Access Compliance Report

Public Rights-of-Way

Intersection ID: 10021845	Main Street: BRIXHAM_HILL_AV	Cross Street: N/A	Location: S
ADA ID: B1639F89207D	Ramp Type: Perp	Initial Pass/Fail: Fail	Overall Compliance: No
Severity Score: 25			
Codes/Mitigation Info/Possible Solution		Field Measurements/Component Compliance

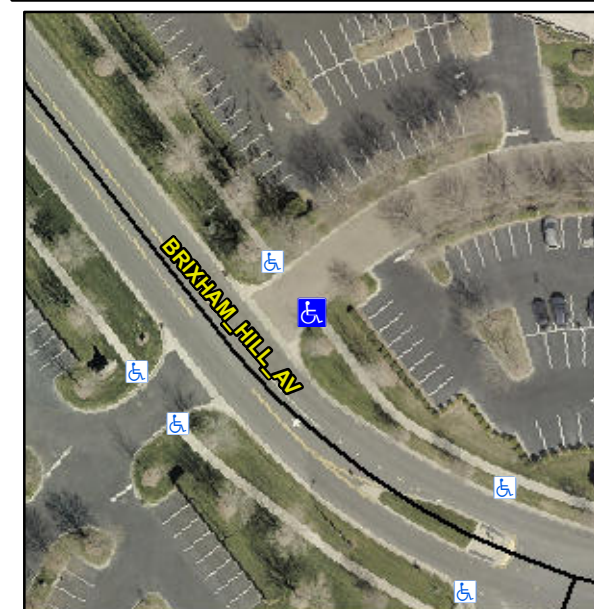
Not Found, R304.2.2

Compliance	Description	Data	Compliance	Description	Data
N/A	Ramp Length (in)	73.0	No	Ramp Slope (%)	13.5
Yes	Ramp Width (in)	59.0	Yes	Ramp XSlope (%)	1.2
N/A	Flare Type LT	N/A	N/A	Flare Type RT	N/A
N/A	Flare Slope LT (%)	N/A	N/A	Flare Slope RT (%)	N/A
N/A	Flare Traversable LT?	N/A	N/A	Flare Traversable RT?	N/A
N/A	Landing Length (in)	N/A	N/A	DWS Provided?	N/A
N/A	Landing Width (in)	N/A	N/A	DWS Contrast?	N/A
N/A	Landing Slope (%)	N/A	N/A	DWS Length (in)	N/A
N/A	Landing X Slope (%)	N/A	N/A	DWS Full Width?	N/A
N/A	Landing Curb? (Y/N)	N/A	N/A	DWS Offset (in)	N/A
N/A	Shared Landing?	N/A			
N/A	Gutter Ponding?	N/A	N/A	Gutter Slope (%)	N/A
N/A	Gutter Lip Ht (in)	N/A	N/A	Gutter X Slope (%)	N/A
N/A	Painted X Walk1?	No	N/A	Painted X Walk2?	N/A
	X Walk 1 Direction	To NW		X Walk 2 Direction	N/A
N/A	X Walk 1 Width (in)	N/A	N/A	X Walk 2 Width (in)	N/A
	X Walk 1 Slope (%)	3.7		X Walk 2 Slope (%)	N/A
	X Walk 1 X Slope (%)	3.3		X Walk 2 X Slope (%)	N/A

Remove & Replace Entire Ramp.
